# UNITED STATES PATENT AND TRADEMARK OFFICE

APPLICATION NO.	FILING DATE	FIRST NAMED INVENTOR	ATTORNEY DOCKET NO.	CONFIRMATION NO.
10/522,890	06/07/2005	Takami Sugioka	1796-161	6601

# Office Action Summary

## **DETAILED ACTION**

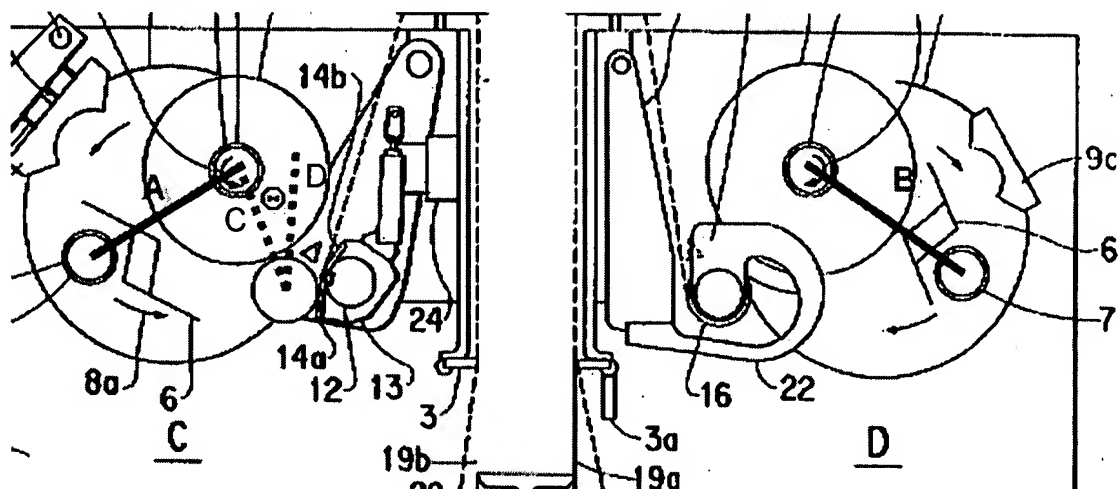
Claims 1-3, 5, 7-10, and 13 are rejected under 35 U.S.C. 102(b) as being anticipated by Daly et al. (US-6015113). Regarding Claim 1, Daly et al. discloses a revolving type winding machine comprising two turret tables C, D having at least two bobbin holders 5a, 5b rotatably mounted thereon, respectively, a press roller 16 and a traverse device 15 are positioned above a horizontal plane in which axes of the at least two bobbin holders lie (Column 5, Line 24-37) upstream from the respective turret table, whereby a bobbin 7 installed on one bobbin holder is switched to a bobbin 7 installed on the other bobbin holder when the yarn wound on the bobbin reaches a predetermined amount characterized in that the two turret tables are disposed on the opposite sides of a yarn passage, rotational directions of a press roller provided for one turret table and a press roller provided for the other turret table are reversed, rotational directions of the one turret table and the other turret table are reversed, and the center of each press roll touching a bobbin holder or a yarn being wound during winding of yarn is located between an imaginary line A (see figure below) passing through the centers of the two bobbin holders projecting from the one turret table and an imaginary line B (see figure below) passing through the centers of two bobbin holders projecting from the other turret table (Figure 1; Column 6, Lines 49-53).

Regarding Claim 2, Daly et al. disclose an imaginary line C (see Figure above) connecting the center of the press roller and the rotating center of the bobbin holder forms an angle  $\Theta$  which is not larger than  $45^\circ$  relative to a vertical line D (see Figure above) (Figure 1). Regarding Claim 3, Daly et al. disclose the imaginary lines A, B connecting the centers of the respective bobbin holders form "A" shape at least upon start of yarn winding (Figure 1). Regarding Claim 5, Daly et al. disclose that the traverse device 15 is disposed between at least two of the two press rollers (Figure 1). Regarding Claim 7, Daly et al. disclose that the press rollers are moveable so that distance between the centers of the press rollers and the at least two bobbin holders are expanded as the amount of yarn wound on bobbins inserted onto the bobbin holders increase (Figure 1). Regarding Claim 8, Daly et al. disclose the turret tables having the at least two bobbin holders projecting therefrom are moveable so that distance between the centers of the at least two bobbin holders and the press rollers are expanded as the amount of yarn wound on bobbins inserted onto the bobbin holders increase (Figure 1). Regarding Claim 9, Daly et al. disclose the press rollers
